**CEDAR CREEK STREAM AND WETLAND RESTORATION  
PROJECT  
MONITORING REPORT  
MONITORING YEAR 3  
FINAL**

SAMPSON COUNTY, NORTH CAROLINA  
CONTRACT No. 005011 - PROJECT No. 95718  
USACE ACTION ID No. 2012-00389 – NCDWR PROJECT No. 2013-0186

RE: Cedar Creek Stream and Wetland Restoration Site: MY3 Monitoring Report  
(NCDMS ID 95718)

Listed below are comments provided by DMS on January 31, 2018 regarding the Cedar Creek Stream and Wetland Restoration Site: Year 3 Monitoring Report and RES' responses.

- Conservation Easement
  - Vegetation Plots
  - Cross Sections
  - Crest Gauge
  - Bank Pin
  - Top of Bank
  - P1 Restoration
  - Headwater Valley Restoration
  - Enhancement I
  - Enhancement II
  - Wetland Restoration Area
- Well Hydroperiod**
- >9%
  - <9%

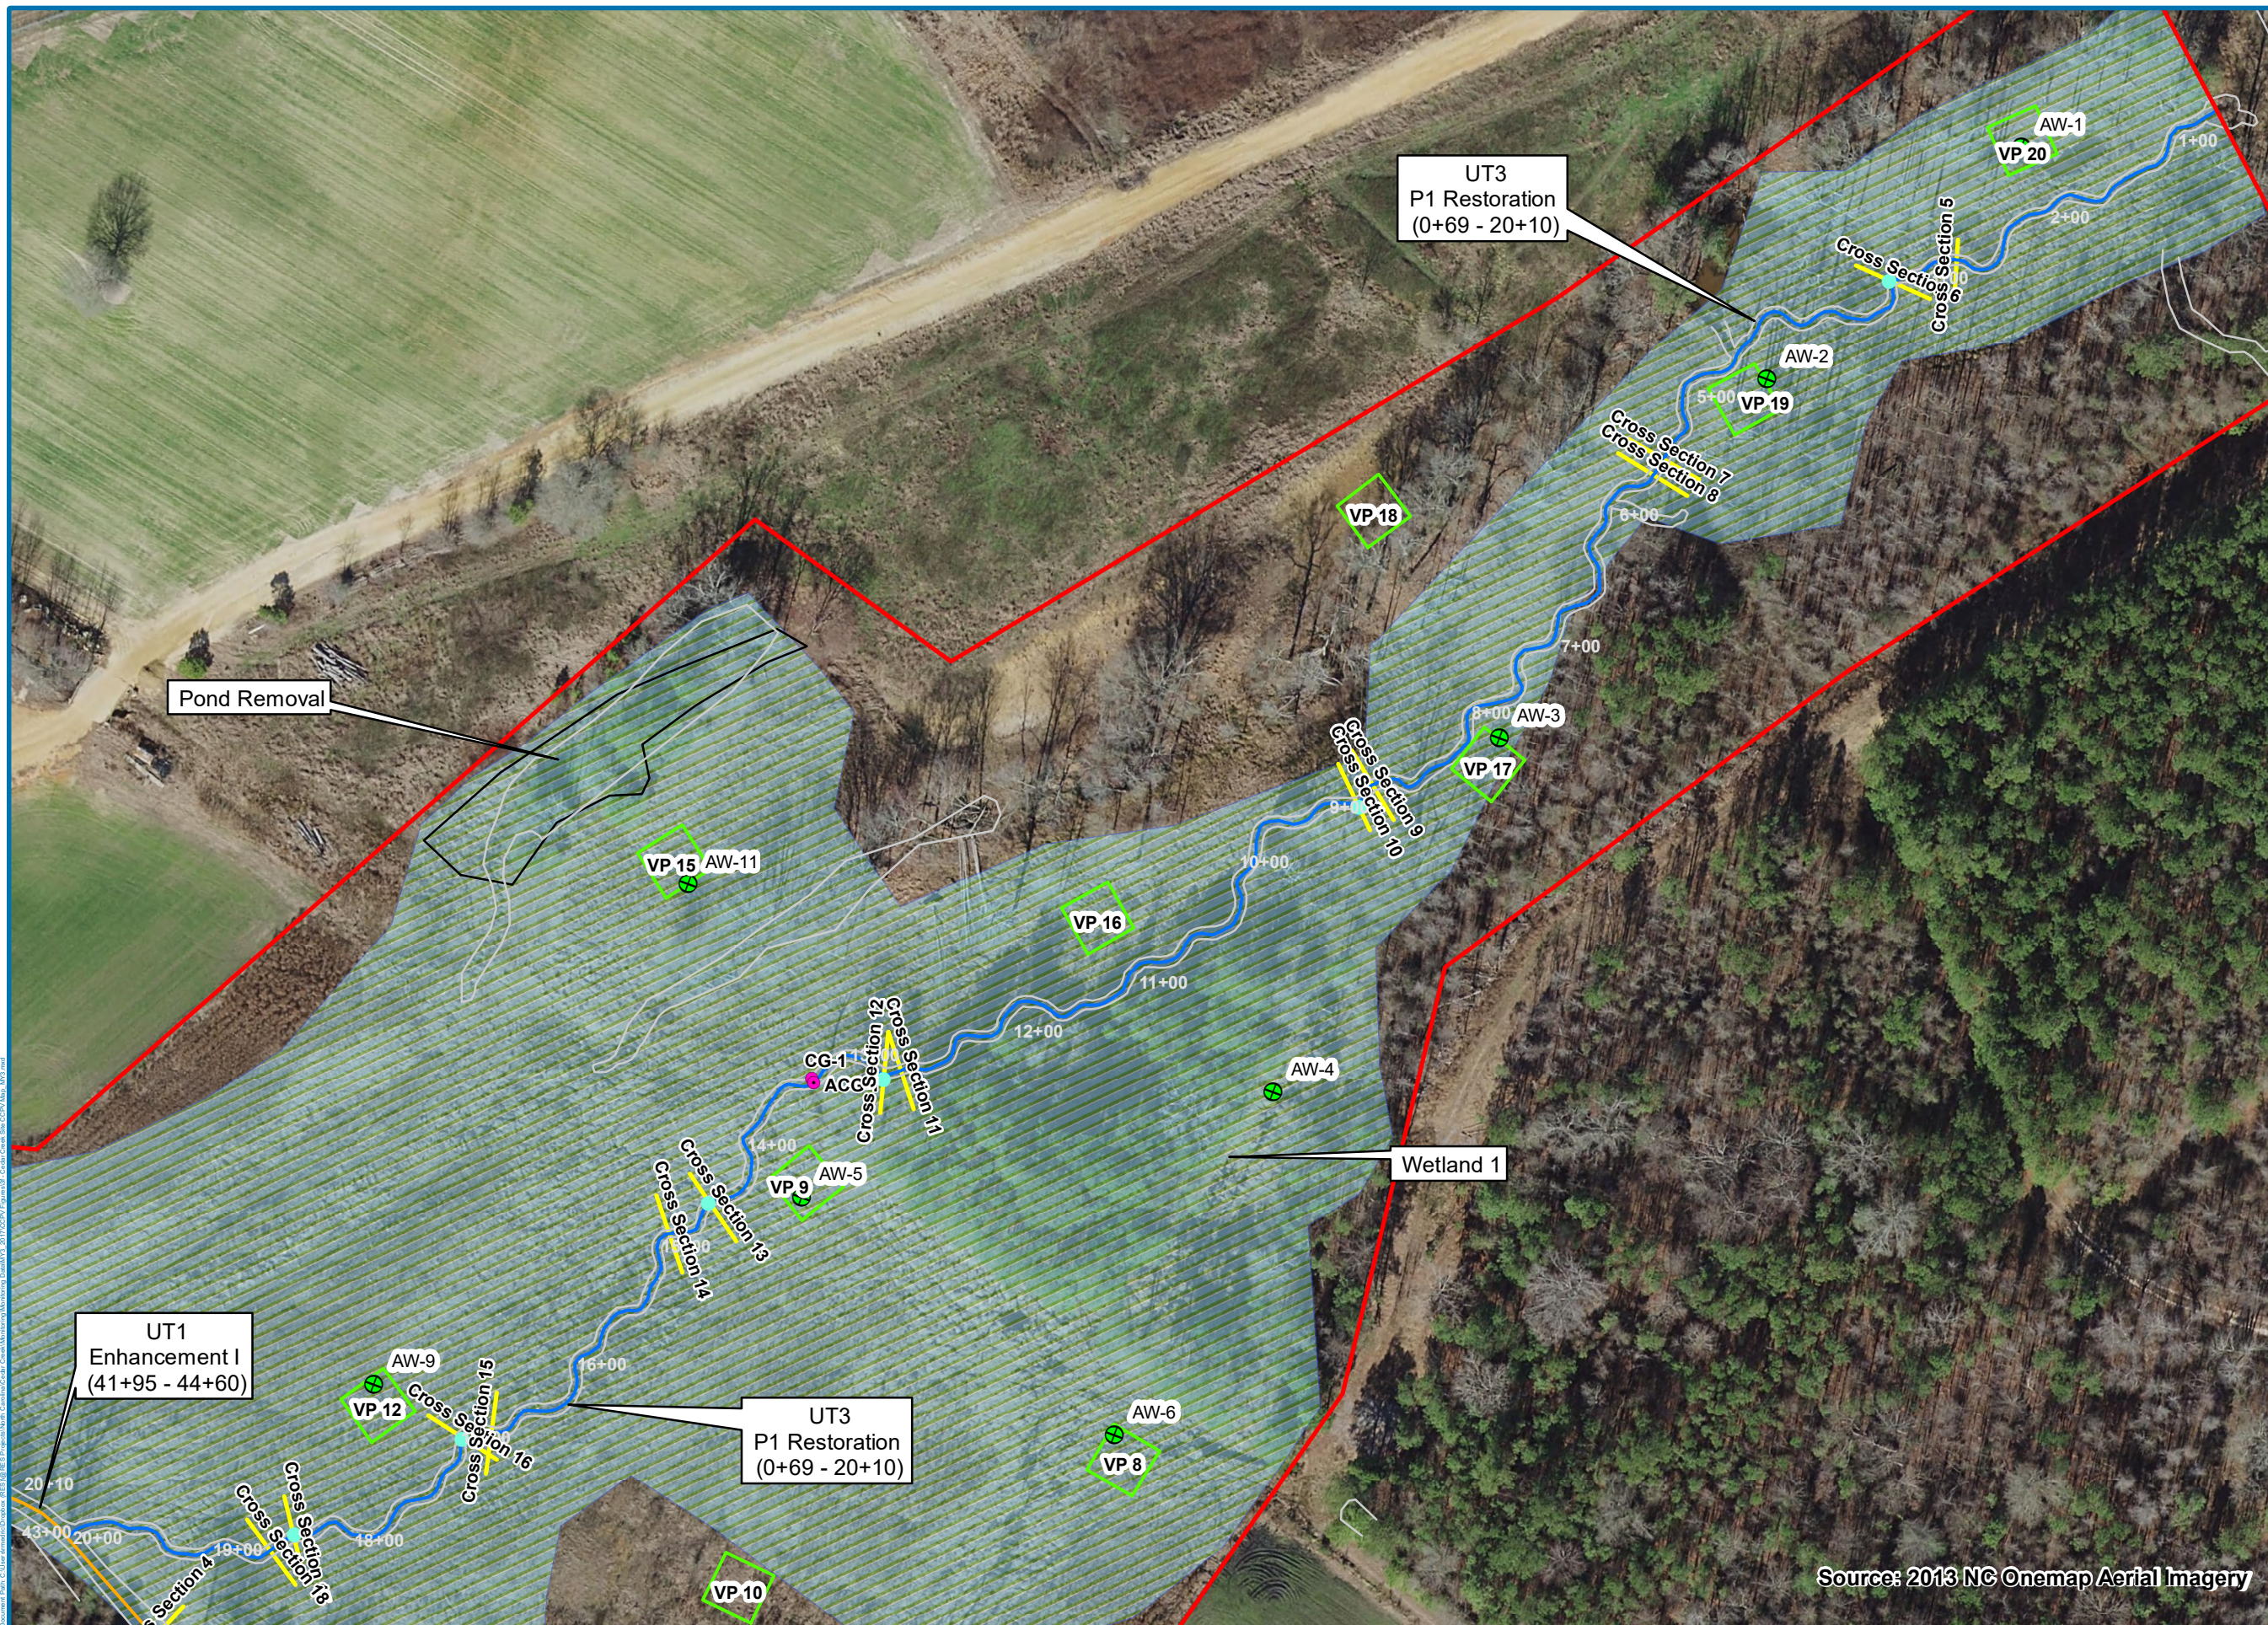
Appendix B, CCPV:

a. Figures 3a through 3f: Use consistent symbology in the Legends for each figure.

b. If there are four SPAs, show SPA4 on the appropriate figure.

c. The locations of bank pins are not shown. Please show on appropriate figure(s).

[Done.](#)
